KENT COUNTY WATER AUTHORITY  
SPECIAL BOARD MEETING MINUTES

February 7, 2008

Installation of insulated shallow water system, The Village Green

**INSULATED WATER PIPE DETAIL**  
 NOT TO SCALE

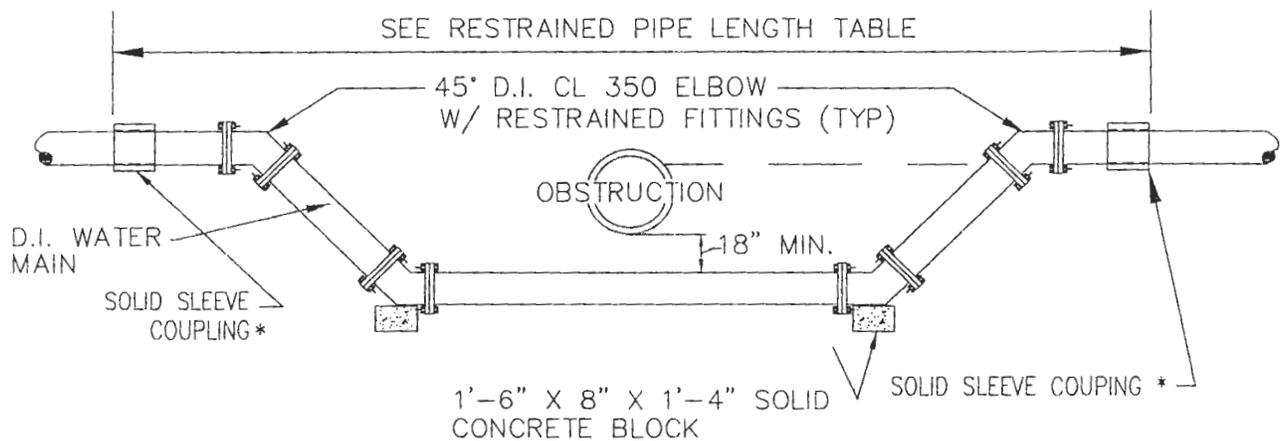
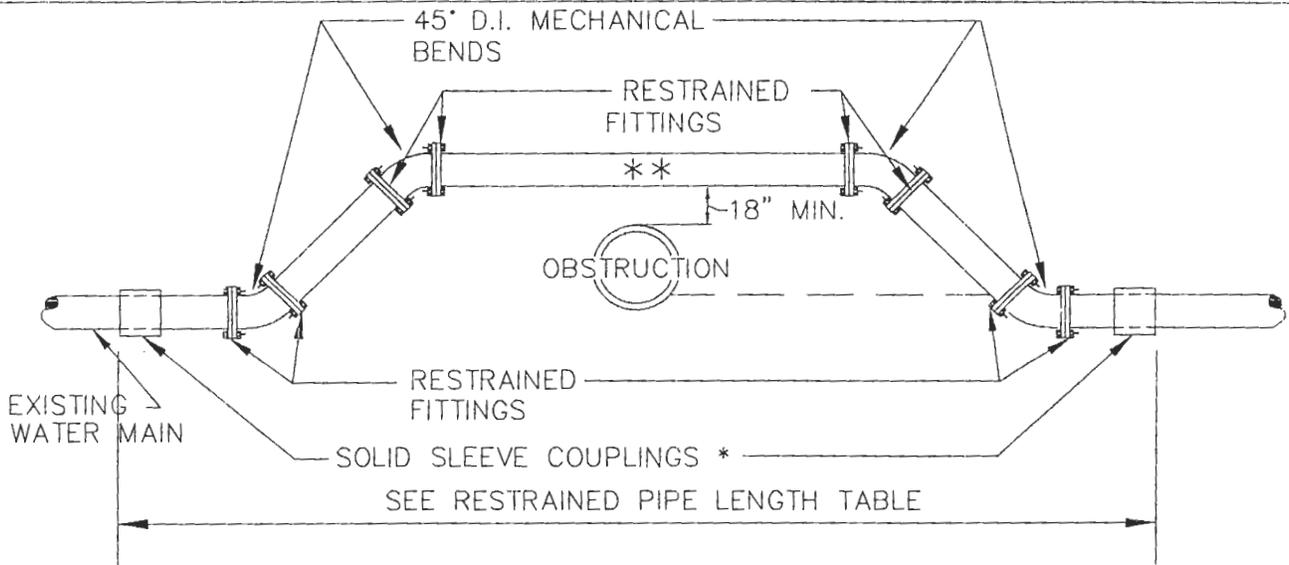
He proposes to insulate the waterline where the inverted “u” goes over the pipe to prevent freezing. The General Manager stated that this was a significant problem in that the placement of water pipe above the frost line is only being requested since the sewer pipe was incorrectly put in below the frost line without regard to Kent County Water Authority regulations and was installed at their own risk and instead of correcting the problem, CNE comes before the Board with a cost-savings plan for its benefit, alone, which is not in keeping with sound engineering principles.

The General Manager prepared a memo dated February 5, 2008 attached as “D” and stated that faulty installation by the developer is the sole reason that we have to deal with this. Board Member Masterson stated that it is obvious that compliance with the KCWA regulations is necessary. The General Manager reminded that the issue is that CNE installed utilities prior to Kent County Water Authority approvals. Board Member Graham added that in trying to make something right which can not be made right, makes no sense.

The General Manager reminded the Board that it does not have the option to approve this proposal pursuant to his February 5, 2008 memo previously attached as “D”. Board Member Gallucci stated that CNE is attempting to correct their problem in defiance of the codes and regulations which can not be waived as it would be a precedent and CNE will need to find another alternative.
